JAMES A. FITZPATRICK NUCLEAR POWER PLANT

AMENDMENT TO FACILITY OPERATING LICENSE

Amendment No. 88
License No. DPR-59

ATTACHMENT TO LICENSE AMENDMENT NO. 88

Figure 3.1-2
Operating Limit MCPR
Versus τ (Defined in Section 3.1.B.2)
FOR ALL FUEL TYPES

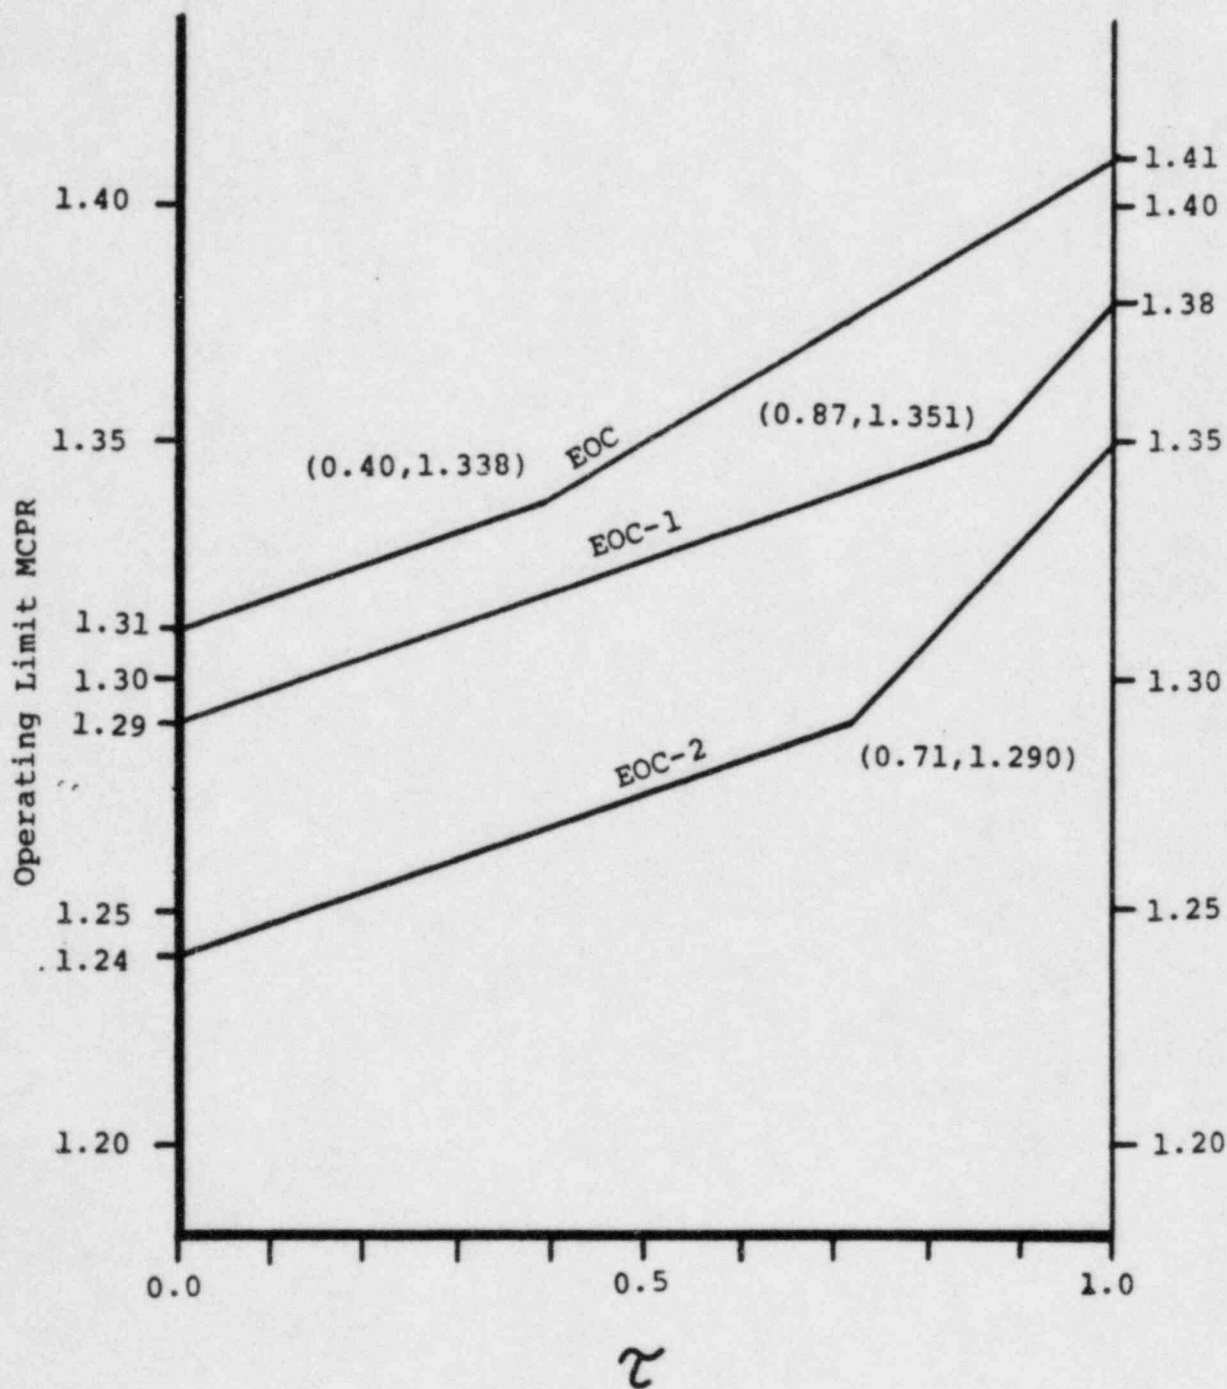
MCPR Operating Limit for Incremental
Cycle Core Average Exposure

<u>At RBM Hi-trip level setting</u>	<u>BOC to EOC-2GWD/t</u>	<u>EOC-2GWD/t to EOC-1GWD/t</u>	<u>EOC-1GWD/t to EOC</u>
S = .66W + 39%	1.24	1.29	1.31
S = .66W + 40%	1.27	1.29	1.31
S = .66W + 41%	1.27	1.29	1.31
S = .66W + 42%	1.29	1.29	1.31
S = .66W + 43%	1.30	1.30	1.31
S = .66W + 44%	1.34	1.34	1.34

Figure 3.5-11

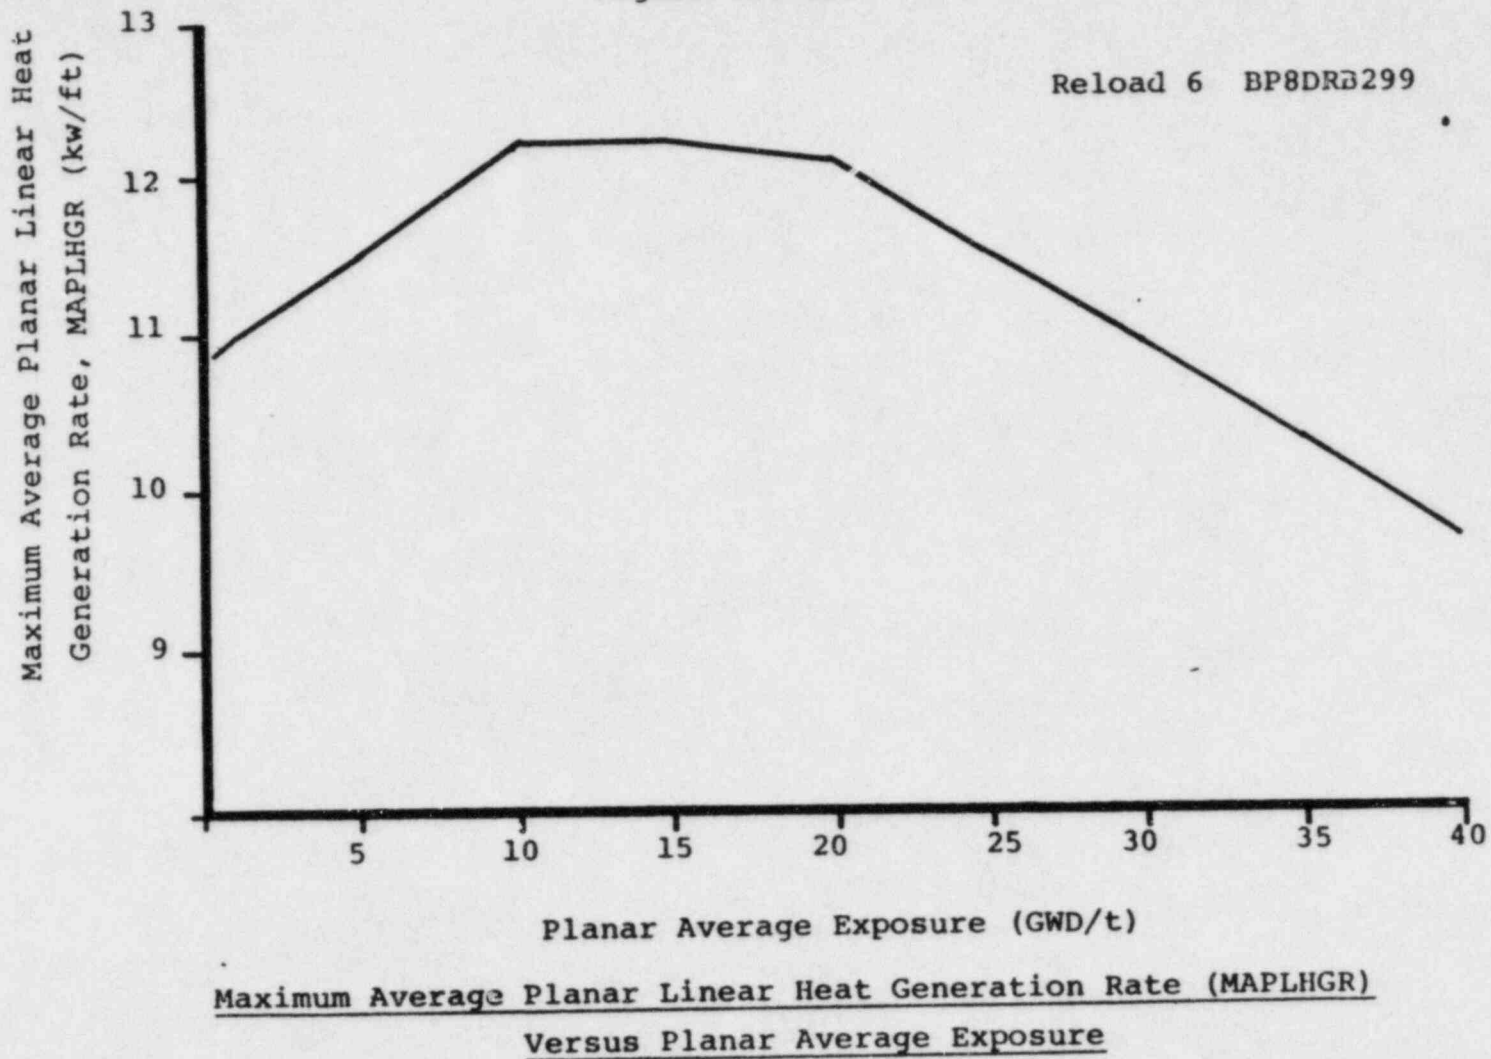
The APLHGR for each type of fuel as a function of average planar exposure shall not exceed the limiting value shown in Figures 3.5-9 through 3.5-11. If anytime during reactor power operation greater than 25% of rated power it is determined that the limiting value for APLHGR is being exceeded, action shall then be initiated within 15 minutes to restore operation to within the prescribed limits. If the APLHGR is not returned to within the prescribed limits within two (2) hours, an orderly reactor power reduction shall be commenced immediately. The reactor power shall be reduced to less than 25% of rated power within the next four hours, or until the APLHGR is returned to within the prescribed limits.

assembly at any axial location and is only dependent secondarily on the rod to rod power distribution within an assembly. Since expected local variation in power distribution within a fuel assembly affect the calculated peak clad temperature by less than $\pm 20^\circ\text{F}$ relative to the peak temperature for a typical fuel design, the limit on the average linear heat generation rate is sufficient to assure that calculated temperatures are within the 10 CFR 50 Appendix K limit. The limiting value for APLHGR is shown in Figure 3.5-6 through 3.5-11.
